ECE/TRANS/WP.29/GRSP/2008/11  
5 March 2008

REGULATION No. 17  
(Strength of seats)

Alignment to the draft gtr on head restraints

Submitted by the expert from the European Commission (EC) \*/

Figure 1. Non-use warning labels

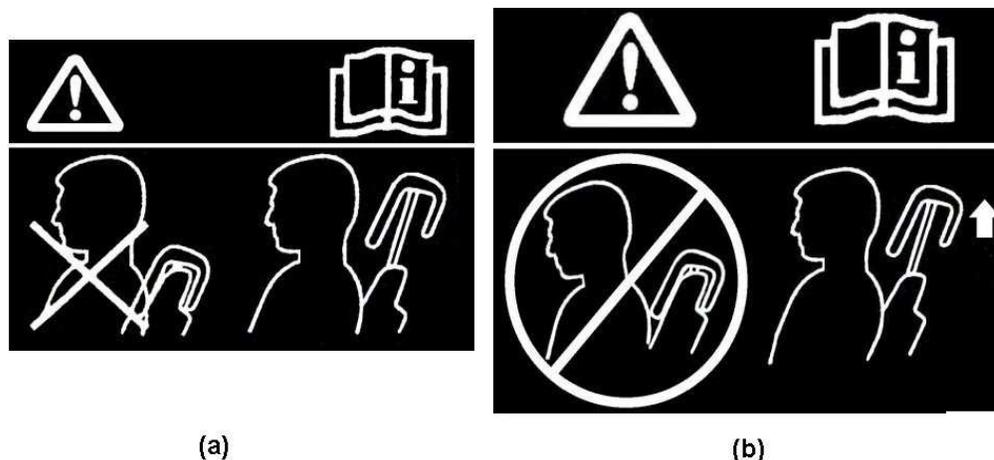
- 5.7.4.5. The head restraint shall be marked with a label in the form of a pictogram which may include explanatory text. The label shall either provide an indication when the head restraint is in a non-use position or provide information to enable an occupant to determine whether the head restraint is in a non-use position. The label shall be durably affixed and located such that it is clearly visible by an occupant when entering the vehicle to the designated seating position. Examples of possible designs of pictograms are shown in Figure 1.**

Figure 3-1 - Measurement of a horizontal gap "a".

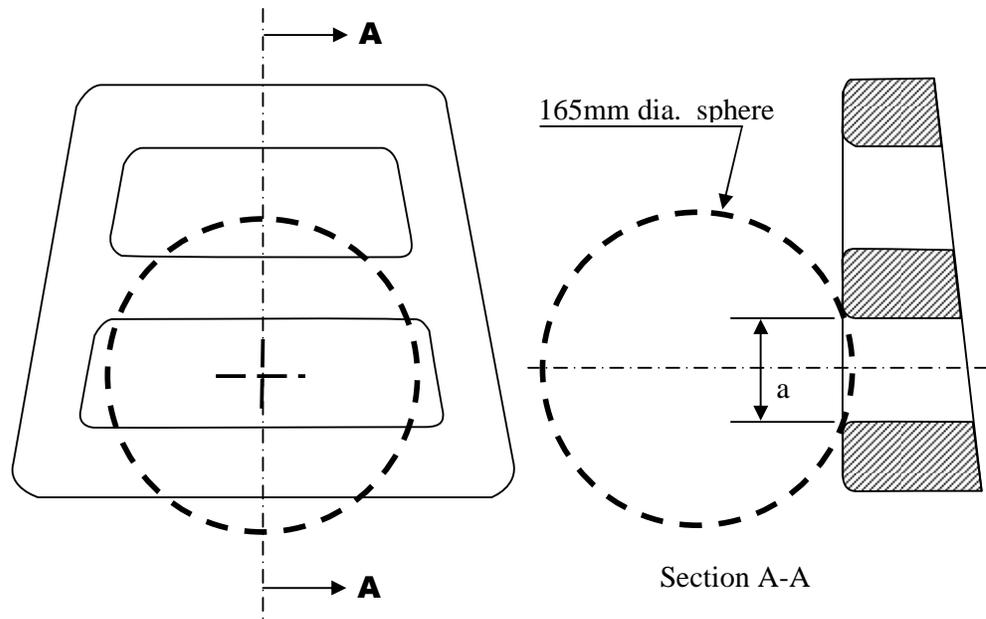
2.7. For gaps within the head restraint, exceeding 60 mm, in order to demonstrate compliance with the requirements of paragraph 5.5.5. of this Regulation, the seat back displacement test procedure described in Annex 6 shall be performed, by applying to each gap, using a sphere of 165 mm in diameter, a force passing through the centre of gravity of the smallest of the sections of the gap, along transversal planes parallel to the torso line, and reproducing a moment of 373 Nm about the R-point.

Figure 3-3

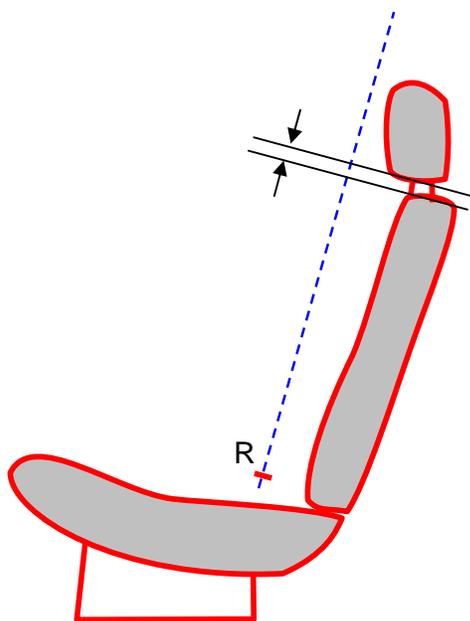
**3.3.** The gap shall be measured as the perpendicular distance between two parallel planes, described as follows (see Figure 3-3):

- (a) each plane shall be perpendicular to the design torso line;
- (b) one of the planes shall be tangent to the bottom of the head restraint;
- (c) the other plane shall be tangent to the top of the seat back.

Figure 6-1.

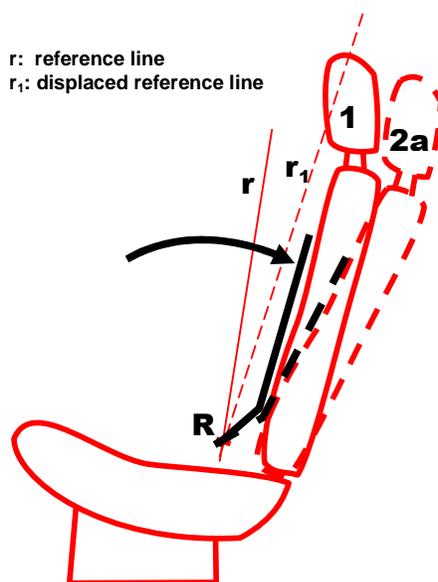
2.3. Establish the displaced torso reference line 'r' by creating a rearward moment of  $373 \pm 7.5$  Nm about the R-point by applying a force to the seat back through the back pan at the rate of 2.5 Nm/second to 37.3 Nm/second. The initial location on the back pan of the moment generating force vector has a height of  $290 \text{ mm} \pm 13 \text{ mm}$ . Apply the force vector normal to the torso reference line and maintain it within 2 degrees of a vertical plane parallel to the vehicle longitudinal centreline. Constrain the back pan to rotate about the R-point. Rotate the force vector direction with the back pan. (see Figure 6-1)

Position 2a. Displaced position by applying to the manikin's back a moment of  $373 \pm 7.5$  Nm about the R-point, defining the position of the displaced torso reference line 'r<sub>1</sub>'.

Figure 10-1.

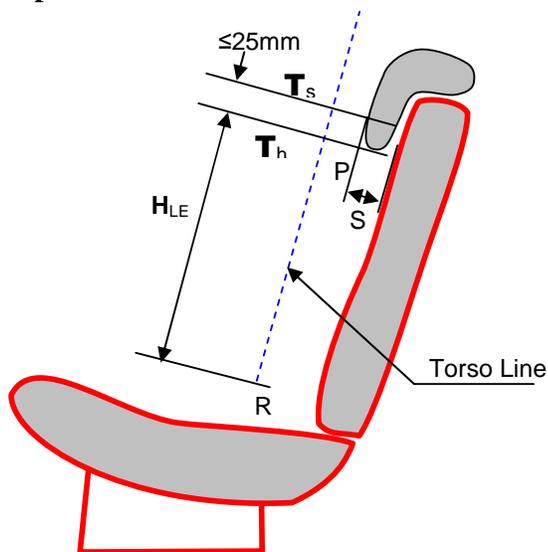
4.1. The HLE and S dimensions are defined in Figure 10-1 which shows a vertical fore-aft plane passing through the R-point (i.e. at the mid point of the designated seating position) intersecting the seat cushion, seat back and the head restraint.

4.2.4. **TH is the line perpendicular to the torso line and tangent to the lower edge of the head restraint.**

4.2.5. **TS is the line parallel to and 25 mm from TH.**
